Service Bulletin No: 52-006

ATA Chapter: 52

**CANOPY - GENERAL
INSPECTION OF THE CANOPY HINGE SCREWS FOR SECURITY OF INSTALLATION****1. Planning Information****A. Effectivity**

Inspection
Figure 1

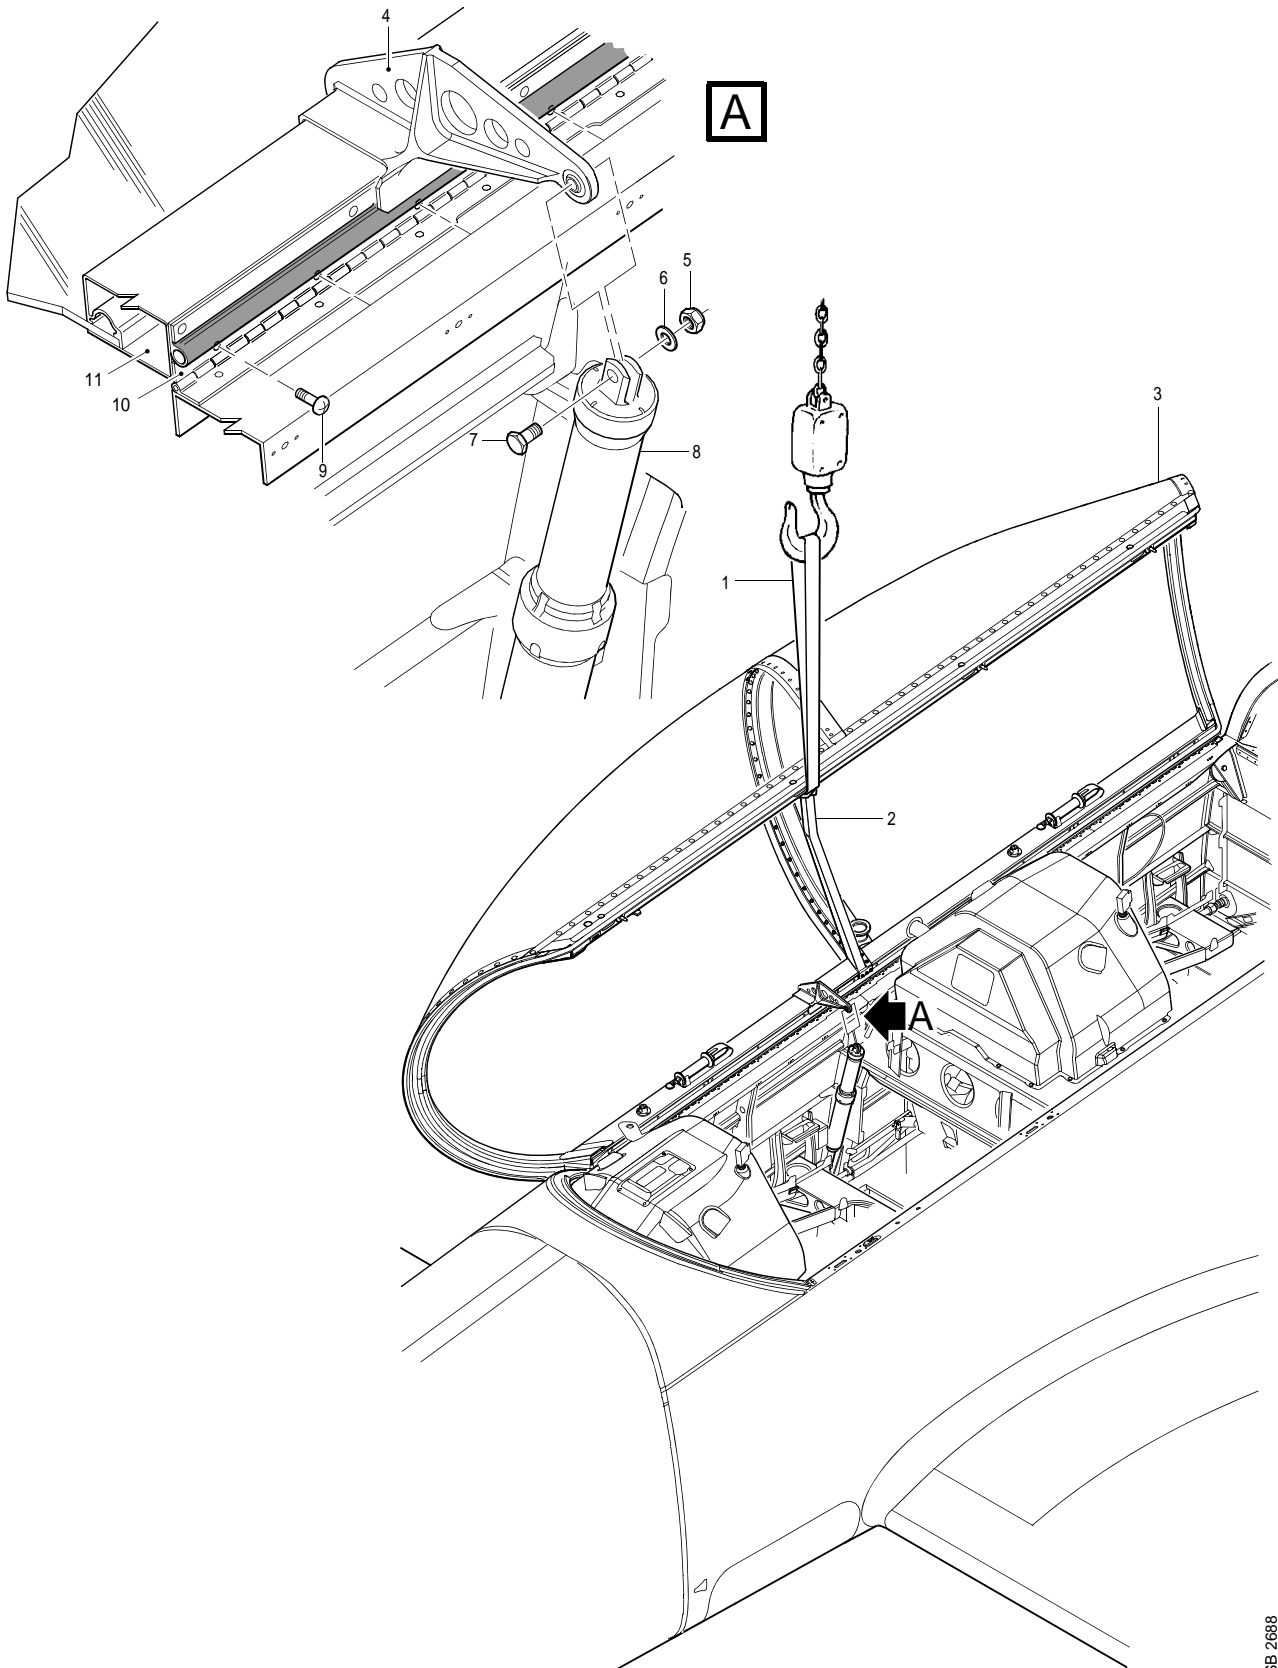
An operator found that some of the screws that attach the canopy to the canopy hinge had become loose.

CAUTION: DO THE PROCEDURE FOR ALL THE SCREWS (9) INSTALLED THROUGH THE CANOPY HINGE (10) BUT LOOSEN/REMOVE ONLY ONE SCREW AT A TIME.

- (6) Loosen one screw (9) at a time, two turns, then continue to loosen for a third turn.
- (7) Make sure that, on the third turn, you can still feel the resistance of the self-locking threads of the rivnut.
- (8) Continue to loosen the screw (9). After the third turn you should feel a small but obvious reduction in the force required to turn the screw.

NOTE: The reduction in the force required to turn the screw indicates that the self-locking of the rivnut is sufficient and adhesive is not required.

Remove the screws and re-install using adhesive (Loctite).

- (9) If you feel the reduction in force as described in Step (8), fully tighten the screw (9).
- (10) If you cannot feel the reduction in force as described in Step (8), do the steps that follow:
 - (a) Remove the screw (9).
 - (b) Use solvent (Material No. P01-008) and a lint-free cleaning cloth (Material No. P02-041) to clean the:
 - Threads of the removed screw (9)
 - Threads of the rivnut in the canopy beam (11)
 - (c) Let the solvent dry.
 - (d) Apply adhesive (Material No. P08-017) to the threads of the screw (9) and install it. Make sure you fully tighten the screw (9).
